## Memorandum

Winnetka Park District

Subject: Special Use Permit Review #1 – Centennial Park + Beach 255 Sheridan Road – (Case No. 24-08-SU) Review Responses (WPD)

Sheet No. CS -7

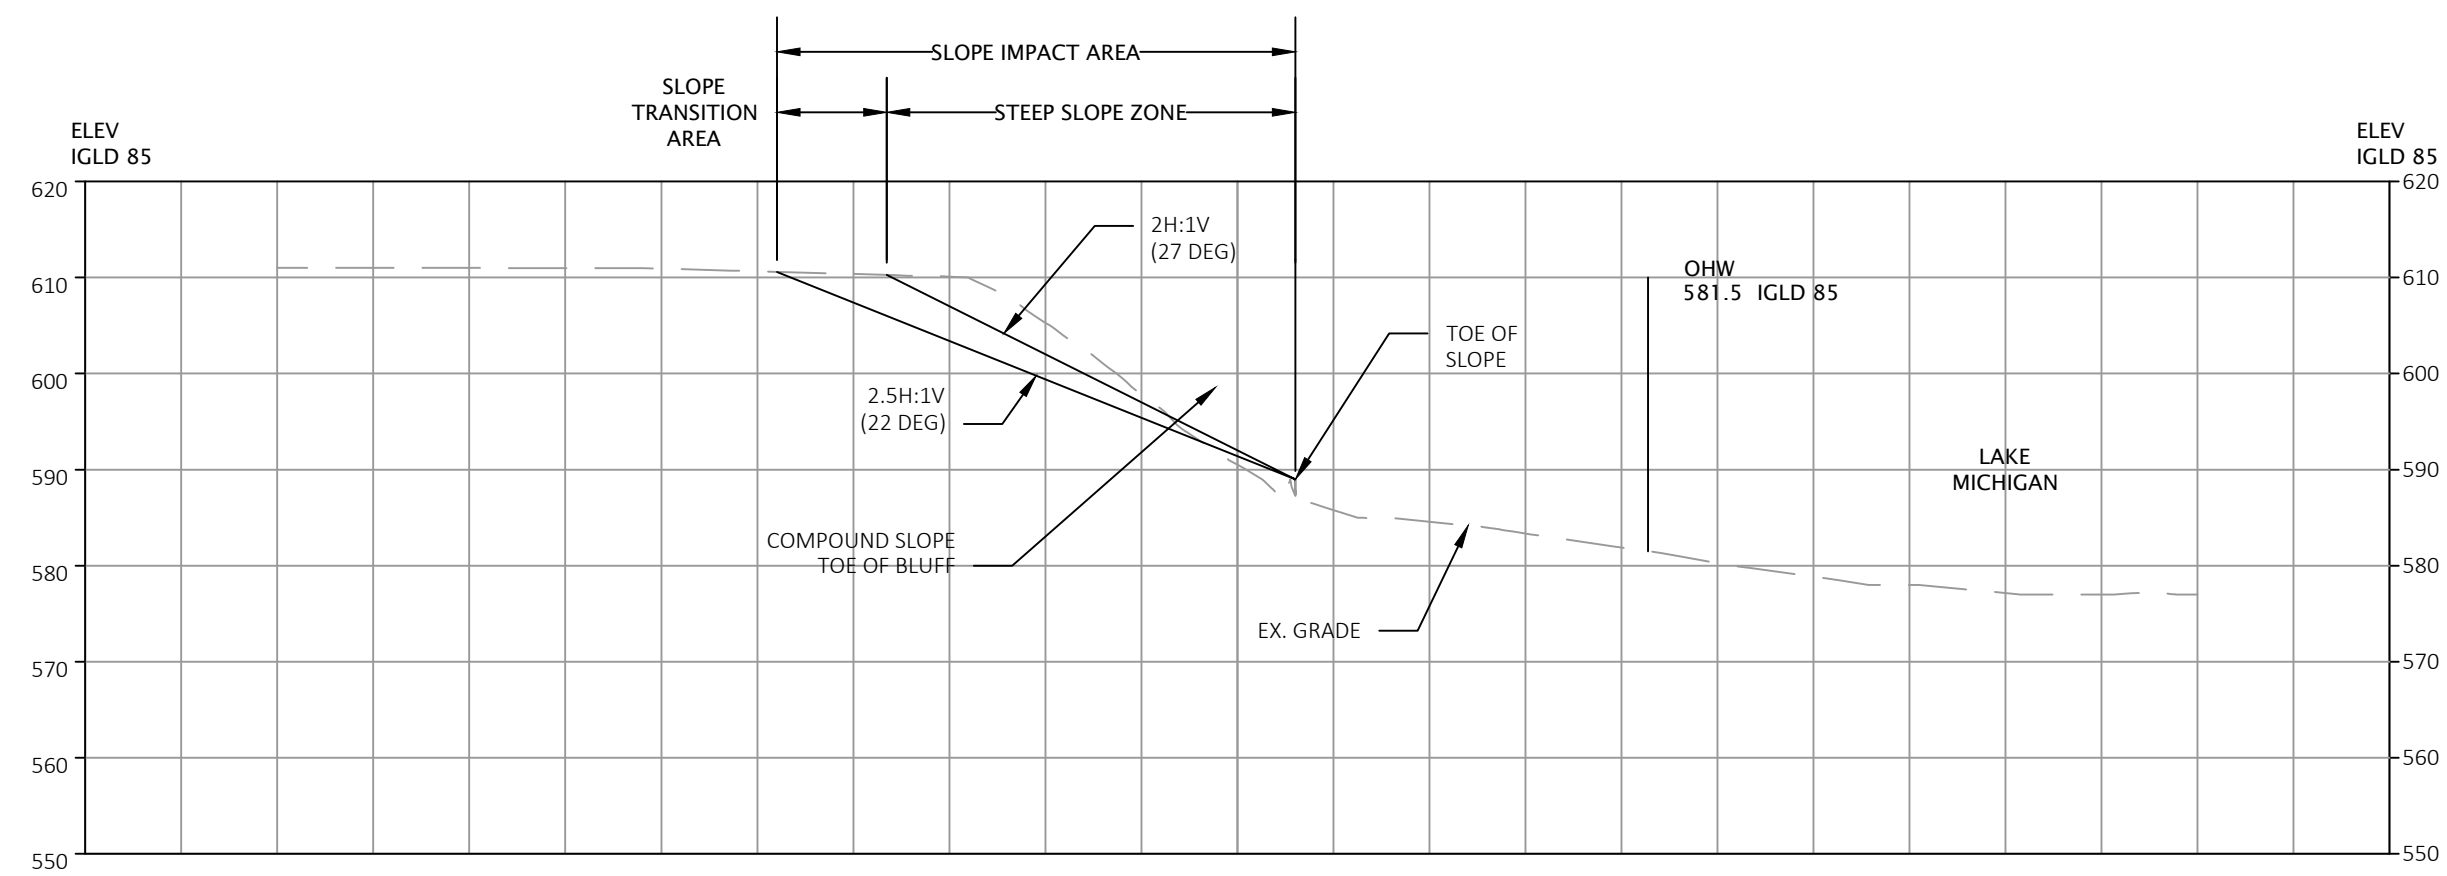
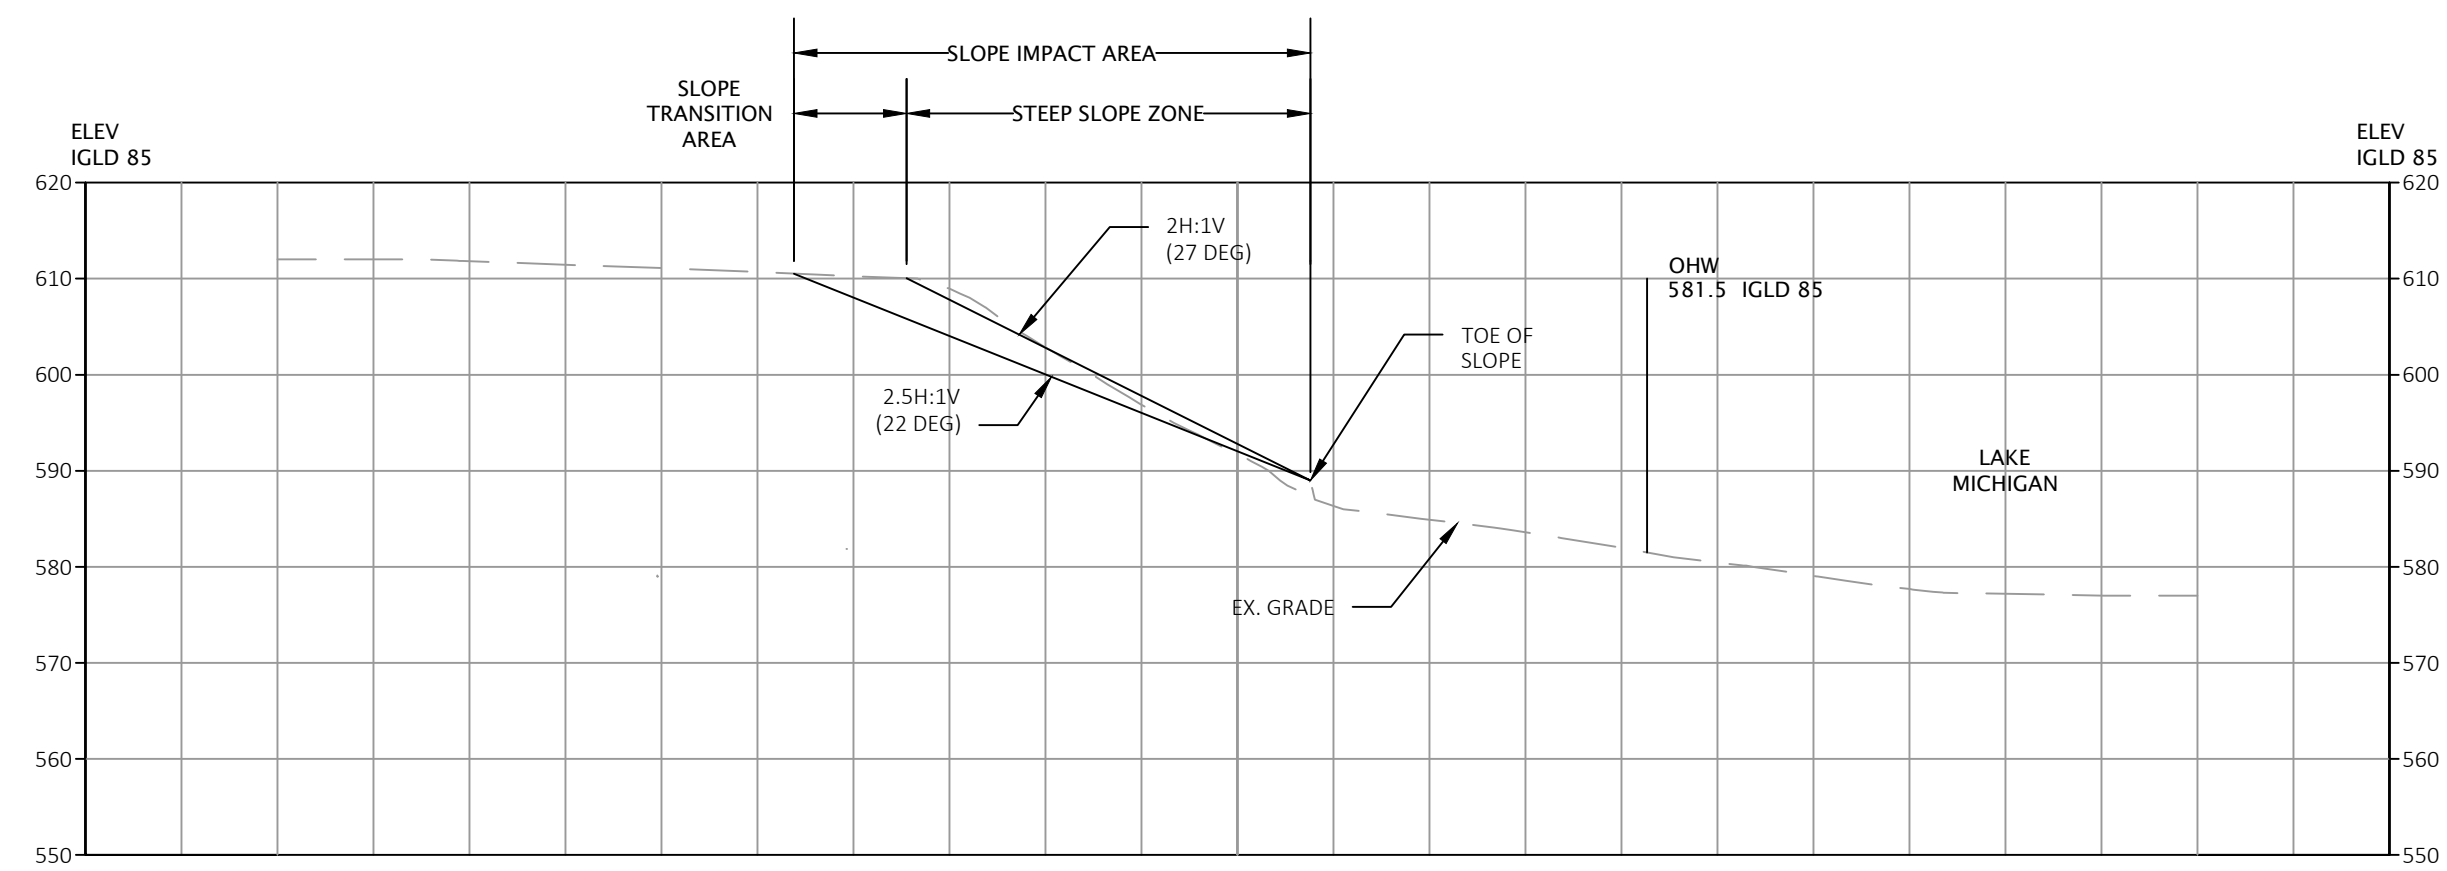
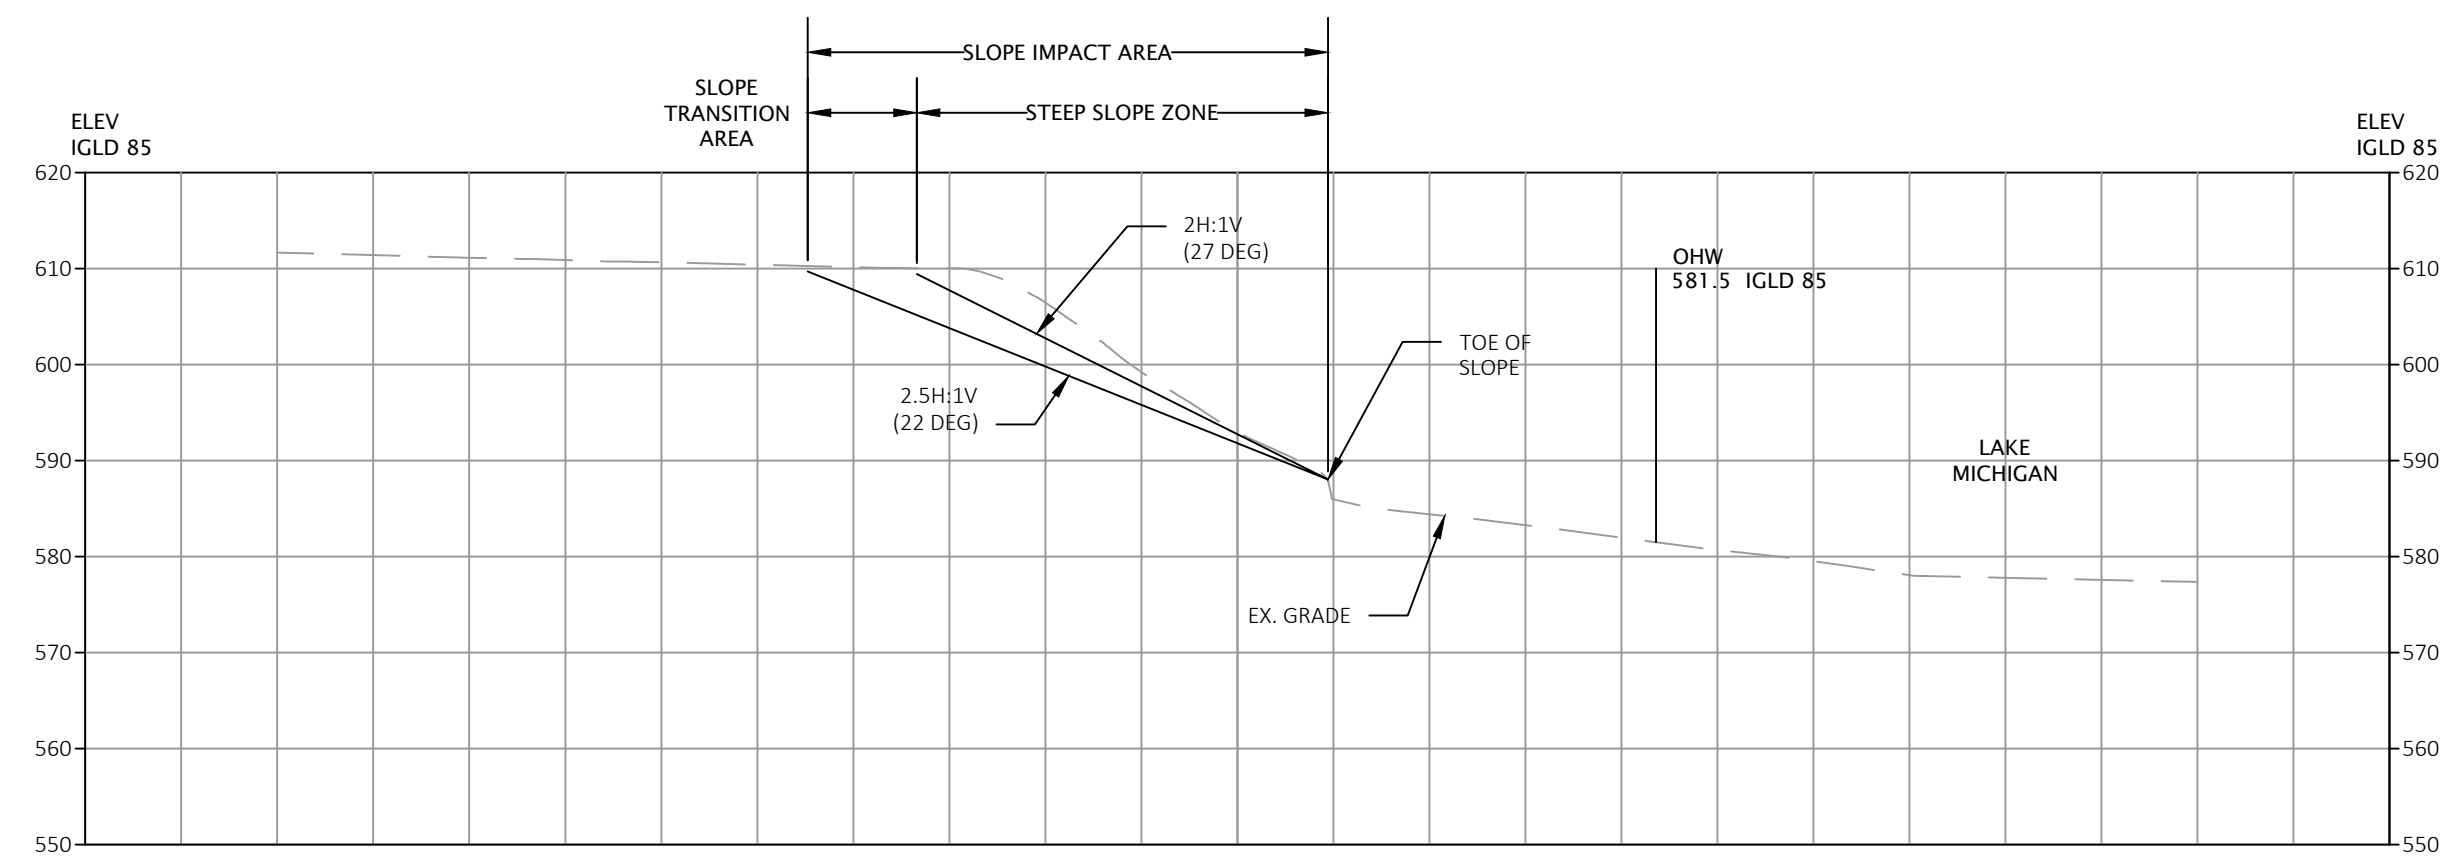
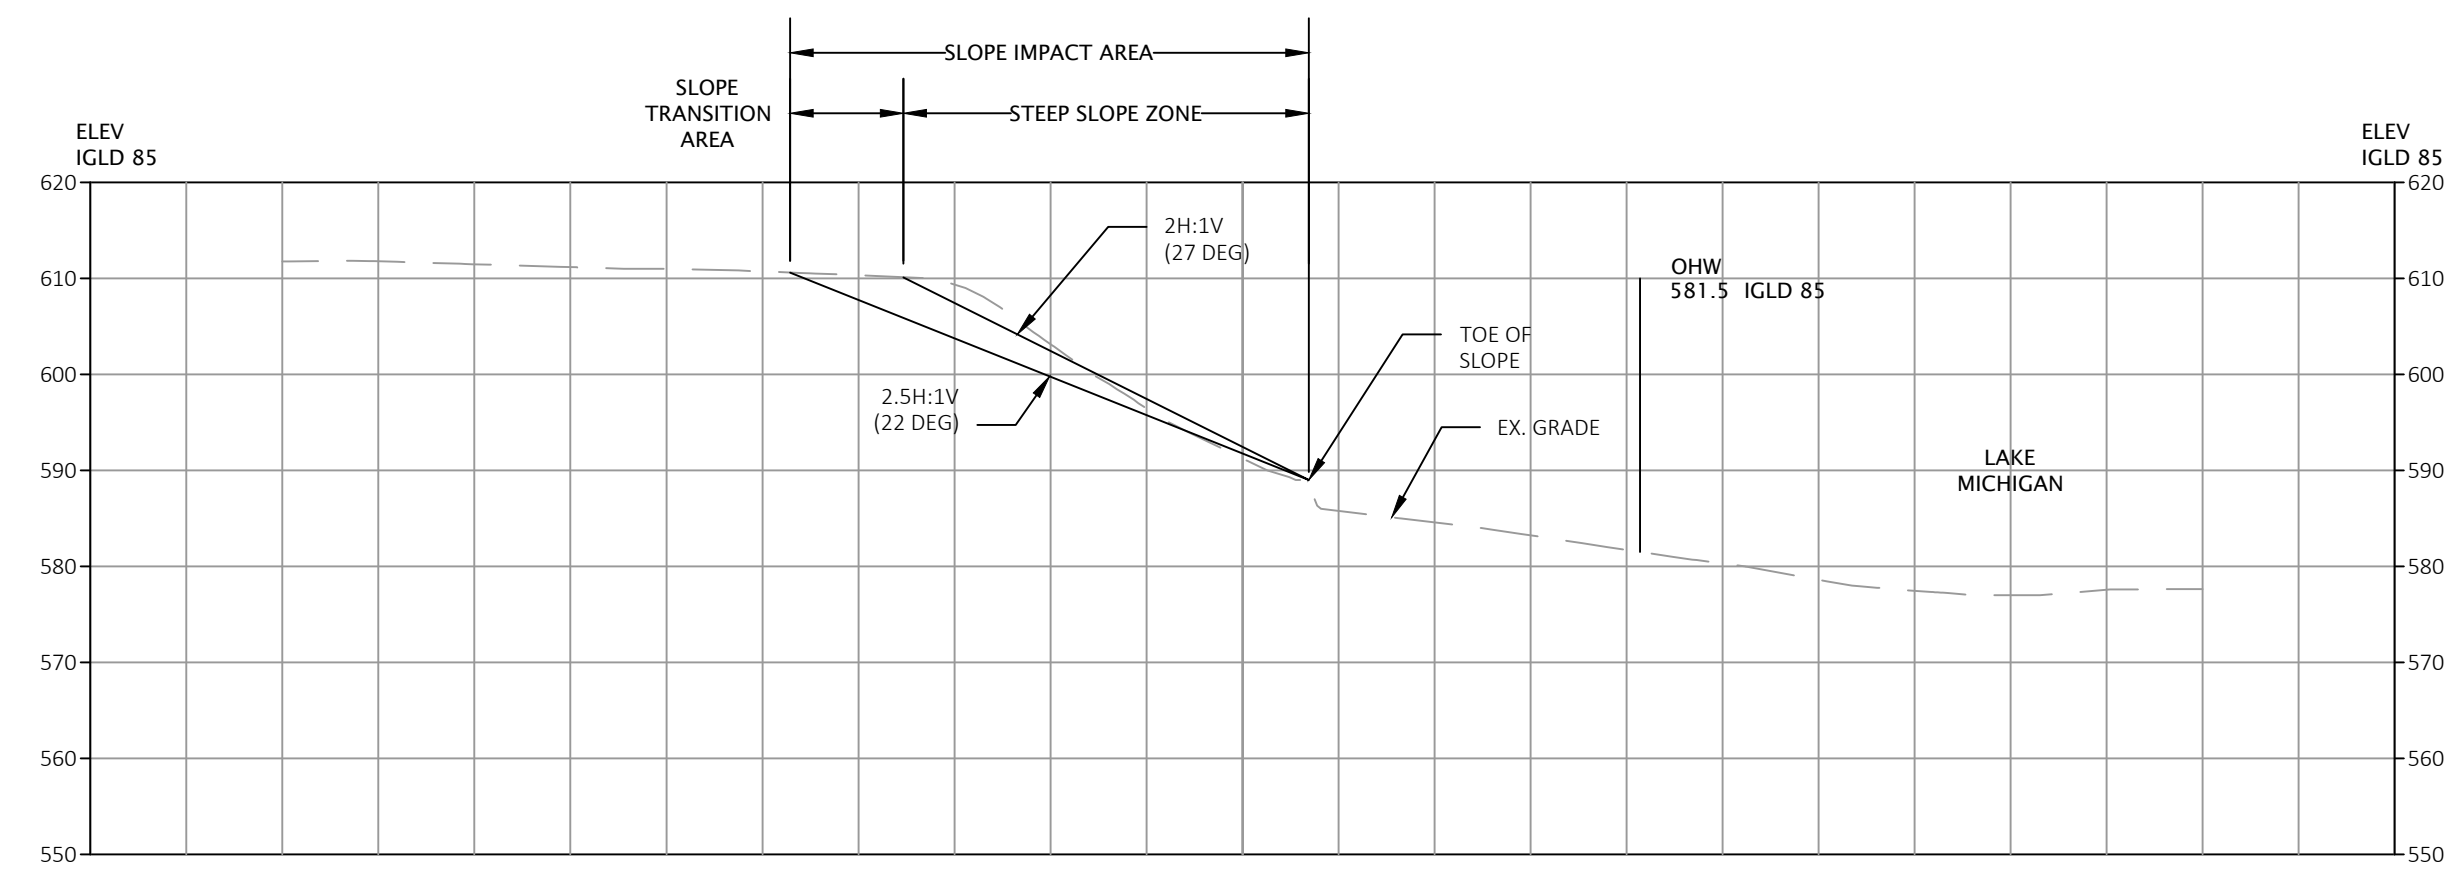
7. You must designate slope impact area, which includes the steep slope zone and slope transition area, on a topographic plan sheet, and provide the necessary cross sections to support these designations. Please see Engineering comments.

1. Per the recently adopted steep slope ordinance, a copy of which is attached, you must demarcate the location of the slope impact area, which includes the steep slope zone and the slope transition Page 4 area, in plan view and provide cross sections every 25 feet. If you have any questions, please reach out to the Engineering Department. Submittal must also provide information supporting how conceptually the design of the proposed plan within the slope impact area meets the Development Standards of Section 17.82.050.

**Response: The Plan Sheet and Cross Sections are noted in drawings CS-6 – CS-10.**

**Response: The Plan Sheet and Cross Sections are noted in drawings CS-6 – CS-10.**
